PENNSYLVANIA POWER & LIGHT COMPANY  
SUSQUEHANNA STEAM ELECTRIC STATION  
OFFSITE DOSE CALCULATION MANUAL

Rev. 1

## SUMMARY OF ODCM CHANGES

FIGURE 5  
 ENVIRONMENTAL MONITORING LOCATIONS  
 WITHIN ONE MILE OF THE SSES

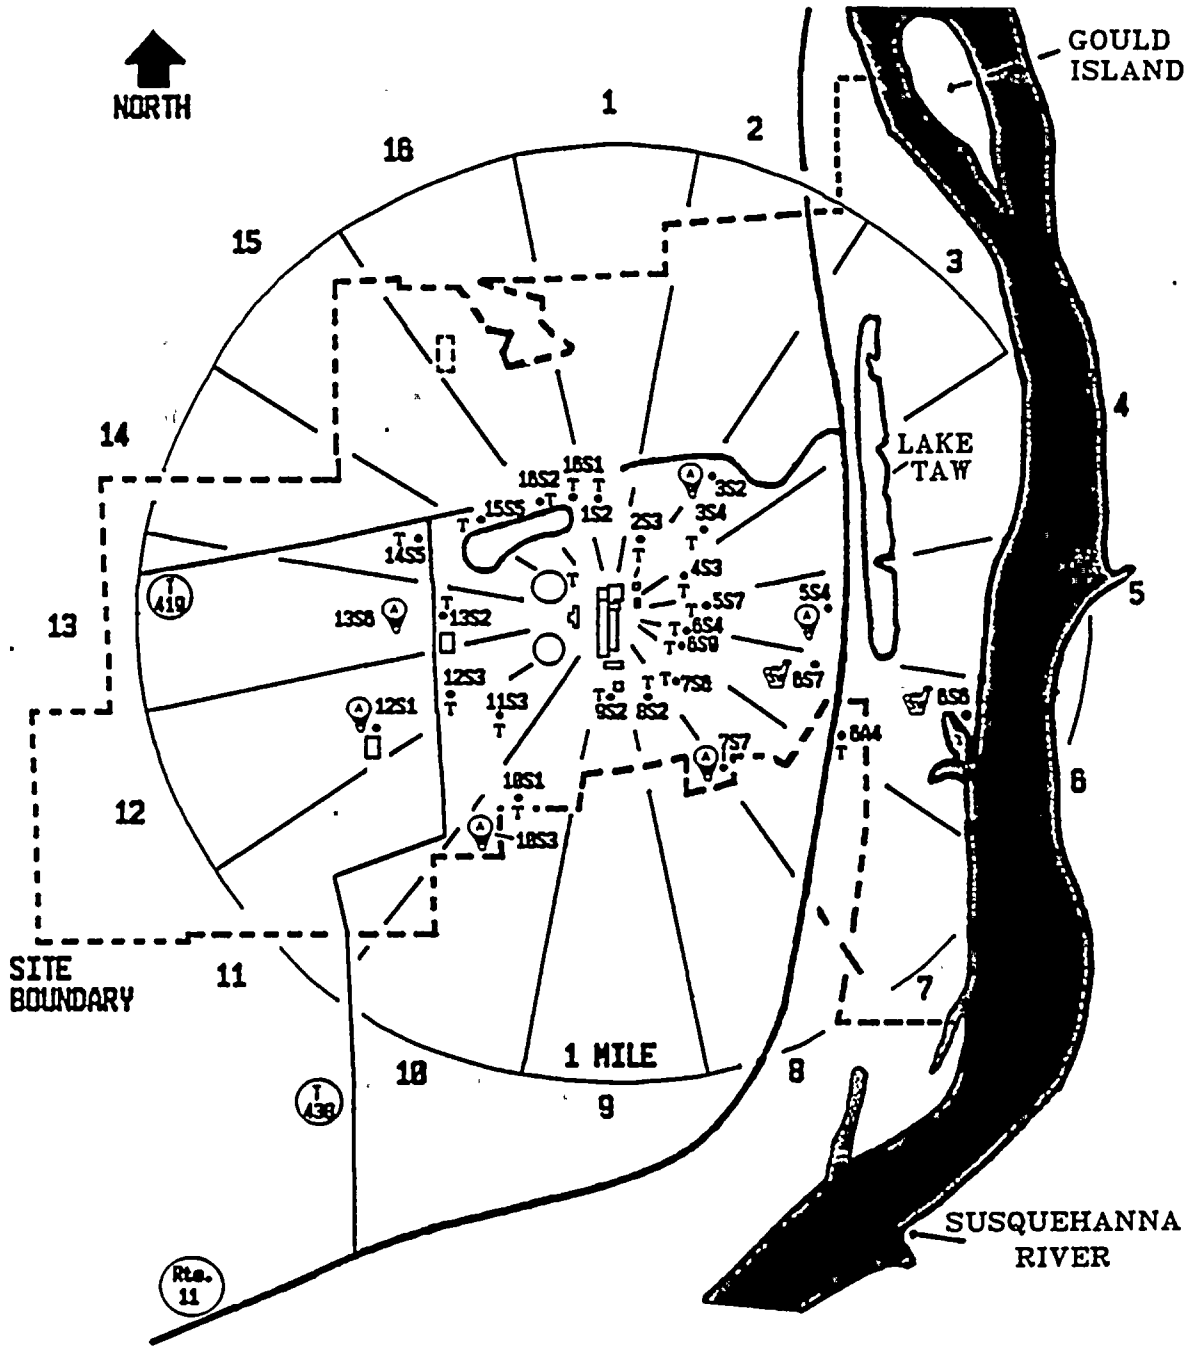
2. Three environmental monitoring TLD stations have been eliminated. Location 3D1 was eliminated due to the removal of the air sampling station at this location, with eventual dismantling of this station. Location 3F1 was removed due to its relatively large distance from SSES, and the interference from overgrown vegetation at the monitoring location. Location 3G5 was eliminated due to concern for safety of sampling personnel when changing out the TLD near a high voltage source. The TLD at location 1D2 has been moved due to elimination of the air sampling station at this site. A replacement site is located approximately 50 yards from the original location. Although the difference in distance between the original and replacement sites from SSES is slight, the new site will be redesignated 1D5. The TLD at location 4E1 has been moved closer to a location where the NRC currently co-monitors direct radiation. The new location is approximately 100 yards from the original, and will be redesignated 4E2. The TLD at location 14E1 has been moved significantly closer to SSES. This new location was sought because of concerns for traffic hazards posed to sampling personnel who change out this badge. The new location is designated 14B3 and is located 1.3 miles WNW.

3. Three particulate/radioiodine air sampling stations have been moved and re-designated. Station 15S4 has been moved to a point 0.4 miles southeast of SSES, at the end of Kline's Road. This station is now 7S7. Station 1D2, in Mocanaqua, has been moved to a point 0.6 miles south-southwest of SSES (east of Confer's Lane, south of the Tower's Club), and is re-designated 10S3. Location 3D1 has been relocated to 0.4 miles west of the former laydown area (west of Confer's Lane); this station is now 13S6.
